ASSESSMENT REPORT

MIRANDA DENTAL HOSPITAL MP 11_0009 (MOD 3)

This report is an assessment of a request to modify the Project Approval MP 11_0009 for the Miranda Dental Hospital at 84-86 Kiara Road, Miranda. The request has been lodged by PPD Planning Consultants on behalf of Russo Family Trust (the Proponent), pursuant to Section 75W of the *Environmental Planning and Assessment Act 1979* (EP&A Act). It seeks approval to increase the building height, reduce the number of car parking spaces, amend the access arrangements, erect additional signage and various other internal and external design amendments.

Figure 3- Lower ground floor (Proposed MOD 3)

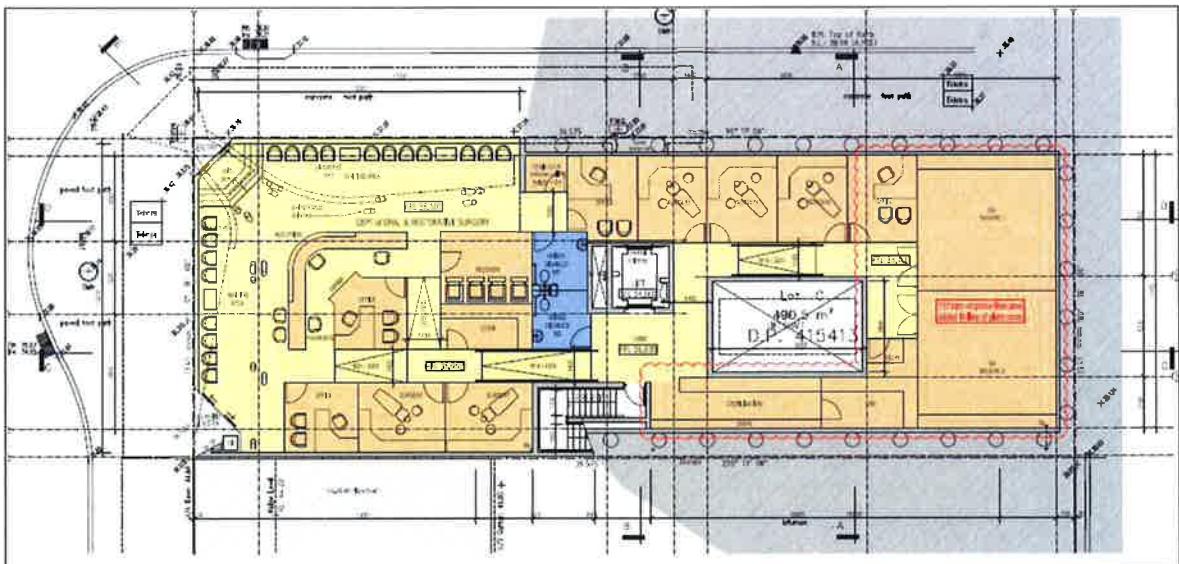
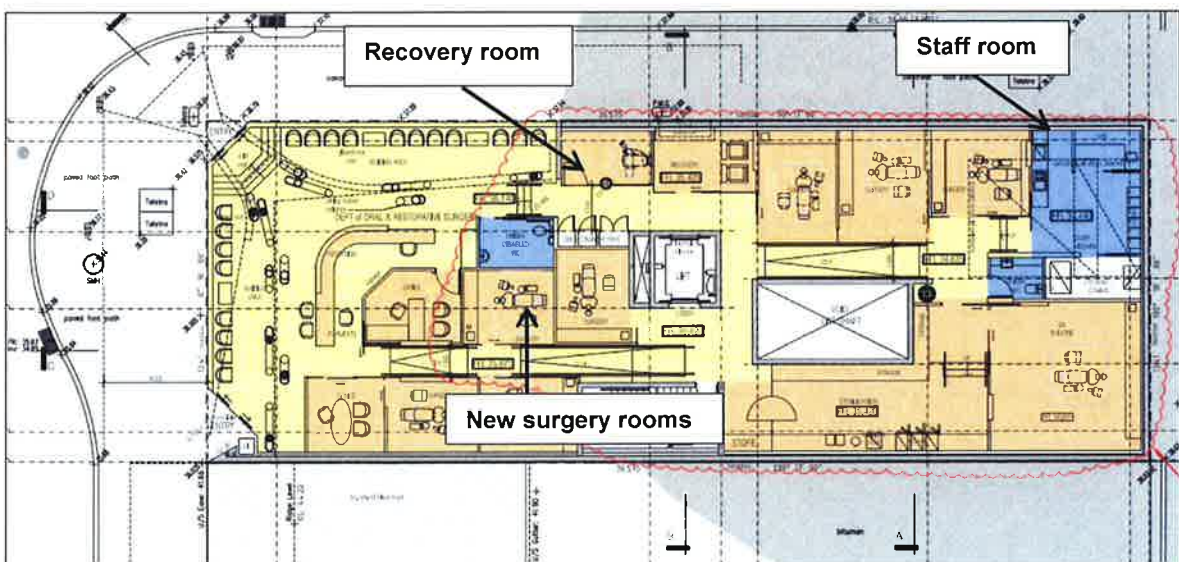
<p><i>Internal Layout Amendments</i></p>	<p><i>Lower Ground Level</i></p> <ul style="list-style-type: none"> • lower the ceiling height to accommodate a substation pit above and adjust the floor levels, stairs and ramps; • adjust the internal layout including: <ul style="list-style-type: none"> - replacement of operating theatre with a staff room; - increase the number of surgery rooms from five to seven; - reconfigure the amenities; - relocate the recovery room; and - add services cupboards; <p><i>Upper Ground Level</i></p> <ul style="list-style-type: none"> • increase the size of the plant and equipment room; • reduce the retail tenancy to 26 sqm; • add a new substation and gas room; • relocate the electrical switch room; and • add a parking valet desk adjacent to the drop-off/pick-up.
<p><i>Other Design Amendments</i></p>	<ul style="list-style-type: none"> • decrease size of rainwater tank in basement to 17,000 litres; • adjust the driveway and waiting bay to accommodate the substation; • modify the kerbline adjacent to the driveway; and • install a new planter box behind the building directory.

Figure 6- Northern elevation (Proposed MOD 3)

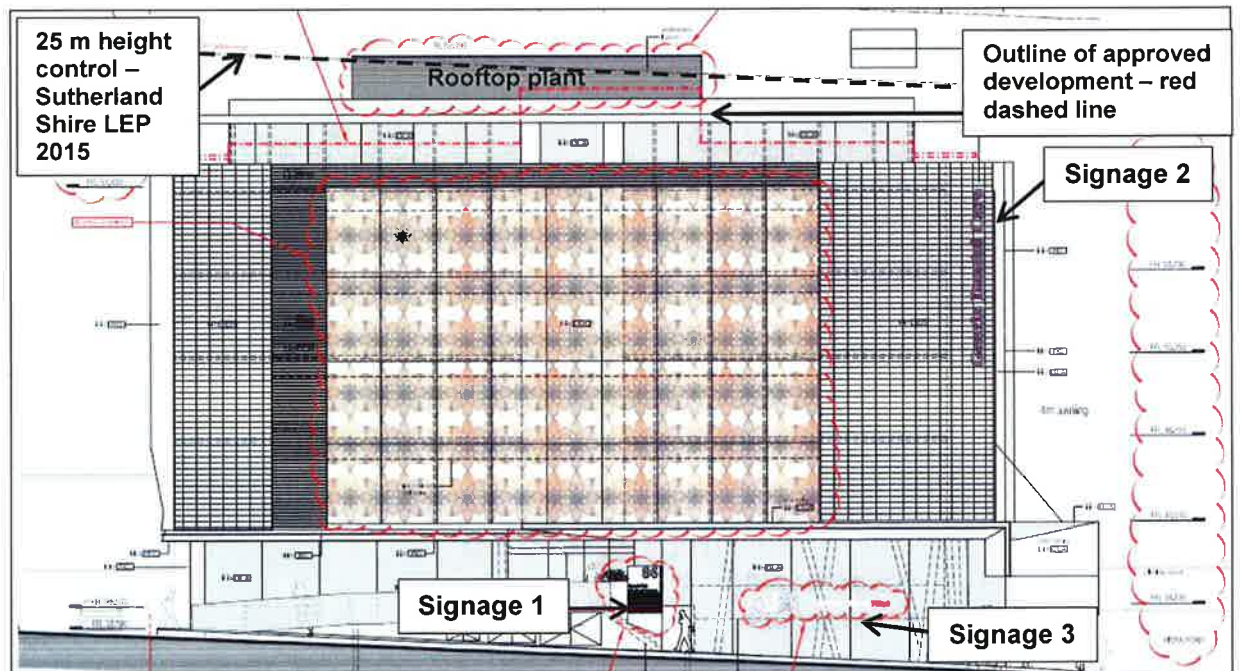
The proposed changes would result in the development slightly exceeding the 25 m height control under *Sutherland Shire Local Environmental Plan 2015* (LEP 2015) by a maximum of 470 mm at the north-western corner of the plant room (refer to **Figure 6**). Council raised concern about the increase in building height above the 25 m height control under LEP 2015.

The Proponent's RtS provides justification for the proposed increase in building height, stating that only the rooftop plant room louvre screening exceeds the 25m height limit, the objectives of the building height standard are still met, the scale of the building is consistent with the character of the street and the minimal increase will not have any amenity impacts.

The Department considers the proposed building height is acceptable, as:

- the encroachment above the 25 m height control is minor and relates to the proposed plant room which is set back from the edge of the building and appropriately screened to ensure it would not form a dominant visual element of the building (refer to **Figure 8**);
- the scale of the proposal is compatible with the adjacent Westfield Shopping Centre which has a height control of 30 m; and
- the additional building height would not result in any unreasonable overshadowing, view loss or privacy impacts on the surrounding commercial properties and the public domain.

Figure 10- Proposed access arrangements

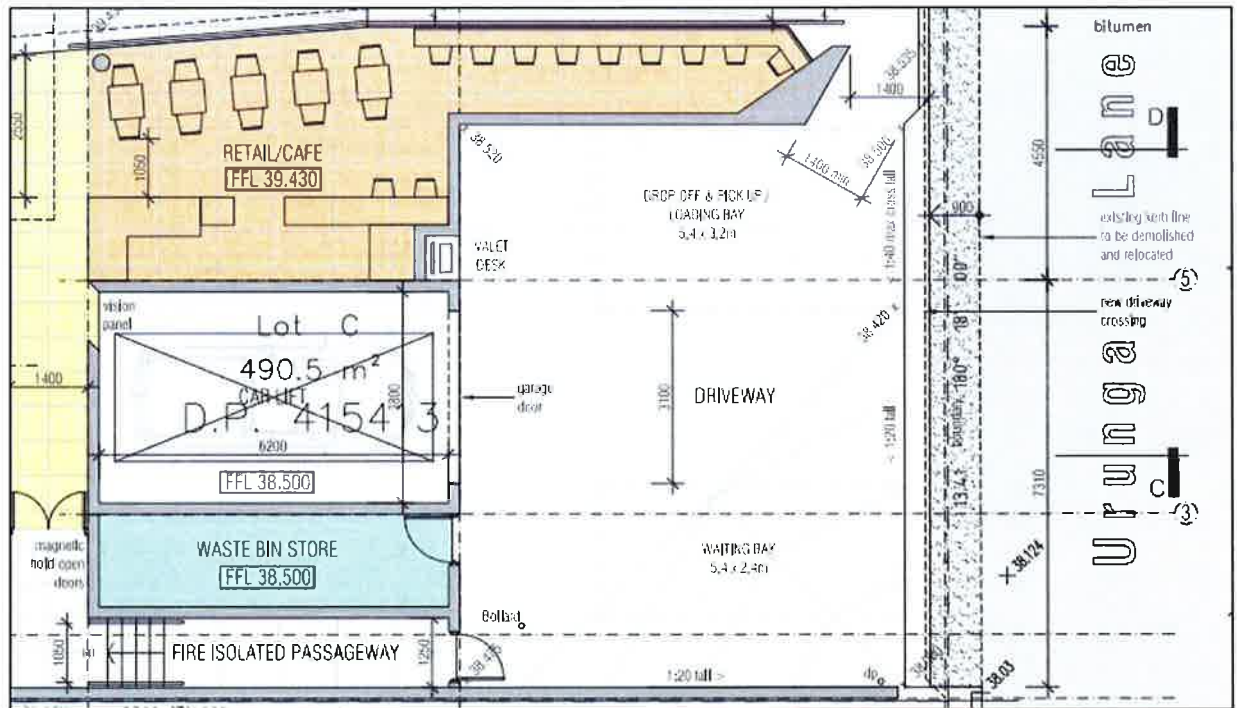
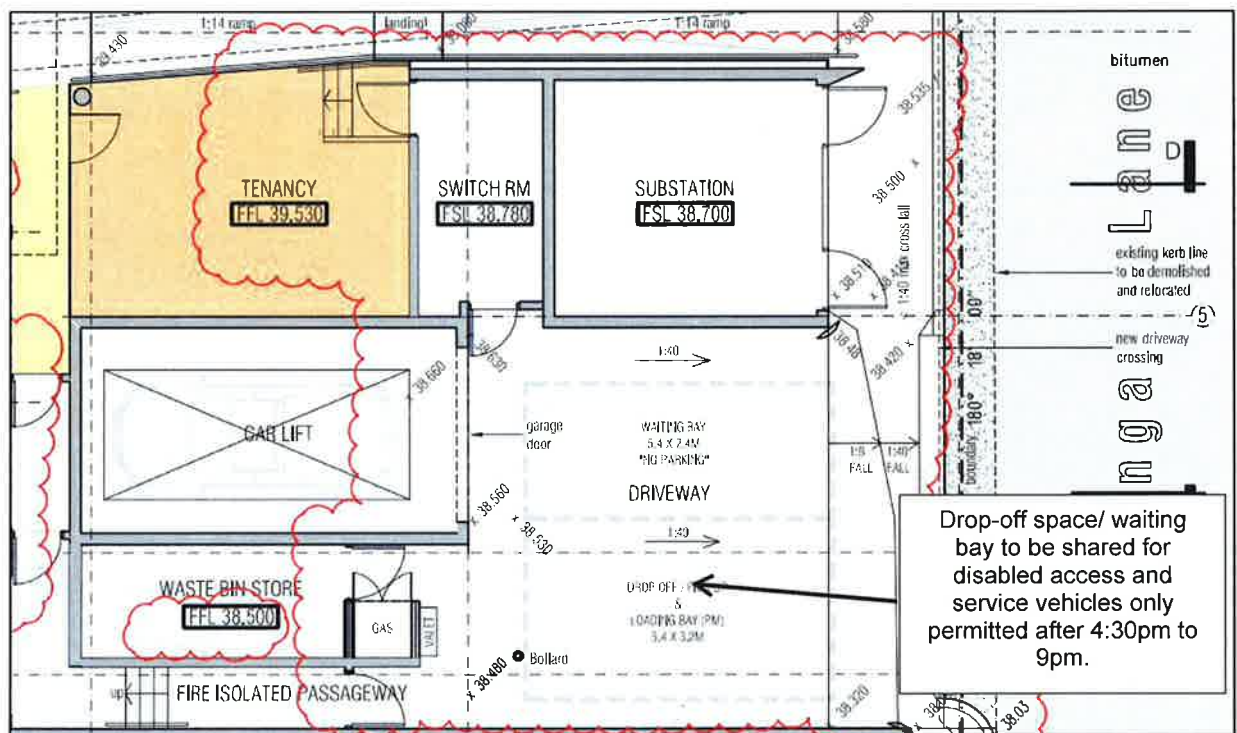
The proposed modification seeks to reconfigure the access arrangements to accommodate a substation required to service the development. This has reduced the space available for vehicular access. A combined drop-off/ pick-up/loading bay and a waiting bay located within the driveway is now proposed (see Figure 10).

Council has raised concerns with the plans showing the disabled car space being shared with a loading bay and considers the disabled car space should remain free and accessible at all times.

In response, the Proponent has confirmed the space would be used as a drop-off/ waiting bay only and not a disabled parking space, but it would allow for people with a disability to be dropped off. The space would also be used as a loading bay for service vehicles after patient visitor hours, between 4:30 pm - 9:00 pm.

The Department considers the proposal would provide appropriate access for persons with a disability in accordance with relevant requirements, noting a valet would be on site to assist patients and to manage other vehicle movements. However, the Department does not support restricting the hours where patients with a disability can make appointments and considers such a restriction to be unreasonable. A condition is therefore recommended requiring the OTMP to be updated to remove this restriction, so that persons with a disability can access the facility at any time during normal patient hours. A condition is also recommended requiring an update of the OTMP to include management protocols to enable staff members with a disability to work at the site and access the carpark. In addition, a condition requiring signage within for drivers entering the site, outlining the waiting arrangements is recommended.

The Department has also considered the potential traffic impacts associated with the modified access arrangements, particularly as a result of the reduced space available for access and the combined use of the driveway for a waiting space. This has the potential to cause conflicts with vehicles entering and exiting the stacker, particularly for visitors and patients who are not familiar with the waiting and entry arrangements. However, the Department notes the access arrangements would be carefully managed in accordance with the OTMP. Further, existing condition G10 requires the provision of a full time valet (during patient hours) who would be responsible for the management of vehicle movements within the waiting / driveway area. The Department considers the provision of a valet during patient hours, in conjunction with appropriate training for staff and instructional signage would ensure access by staff and visitors can be adequately managed to appropriately minimise potential traffic queuing and congestion.

considers this an essential operational requirement as the use of the loading bay for service vehicles during operating hours would result in unacceptable conflicts between staff and patients visiting the site. A condition is therefore recommended requiring all deliveries to take place outside of patient appointment hours. As the site is surrounded by commercial development and does not adjoin any residential premises, the Department considers out of hours deliveries would not cause any unacceptable noise or amenity impacts.
